**RESOLUTION NO. 2025-076
VILLAGE OF CALEDONIA**

**A RESOLUTION APPROVING CERTIFIED SURVEY MAP # _____; & A WAIVER
TO 14-1-5(g)(3)(b) FOR LOT SIZE RATIO EXCEEDING 2.5:1 FOR PARCEL ID 104-04-
22-21-042-000 LOCATED IN THE SE ¼ OF SECTION 21, T4N, R22E, VILLAGE OF
CALEDONIA, RACINE COUNTY, WI**

Plan Commission Staff Report

Re: **Kolb & Holding Certified Survey Map**
Nicholson Road - Parcel ID 104-04-22-21-042-000
Applicant & Owner – Holding & Kolb, Inc.

PROPOSED EASEMENTS

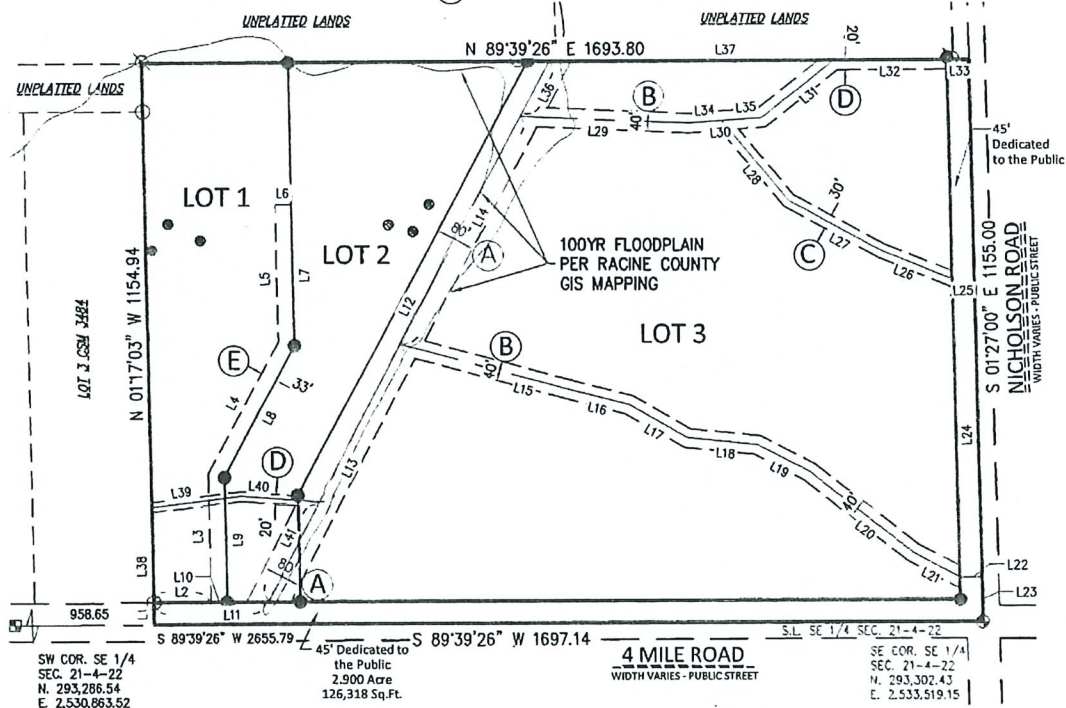
Storm water management requirements are not met by the creation of these parcels. If the thresholds are met during the development of Lot 1 and 2, a Storm Water Management plan and Civil Engineering Drawings shall be submitted, reviewed and approved by the Village. There are multiple drainage channels on the property called out on the Village's Master Drainage Plan and on the proposed CSM. The easements as shown are acceptable to staff and an Easement Agreement shall be entered into and recorded against the property for these easements. The Owner has expressed to the Village that a drain tile installation project is proposed within the primary channel bisecting this property and will be done upon completion of the CSM. The owner shall provide plans and apply for the necessary permits with the Village to improve this channel and provide any other information as necessary.

Nicholson Road and 4 Mile Road are considered Principal Thoroughfares and a 45' Road Right-of-Way shall be dedicated to the Village along the newly created lots. This is shown and is acceptable. Only one driveway access is authorized onto 4 Mile Road per Village Ordinance. This is shown via a shared 33' cross access easement. It is recommended that a maintenance aspect of the easement is included in any documentation and that the recorded agreements are shared with the Village upon recording and prior to the issuance of any building permits.

3. The 2.5:1 ratio waiver to 14-1-5-(g)(3)(b) is approved.
4. The Owner enters into a Storm Water Drainage Easement Agreement with the Village and records it against the property for the drainage channels shown on the proposed CSM.

7. The cross-access easement is recorded, and a copy is provided to the Village. It is recommended to include maintenance language in this easement agreement.

9. Add a graphical representation of the setback requirements to the CSM and identify the 75' setback from the OHWM.
10. Only one driveway access is allowed for both Lot 1 and Lot 2 onto 4 Mile Road (principal thoroughfare). A note shall be provided on the CSM. This is being addressed via the cross-access easement.
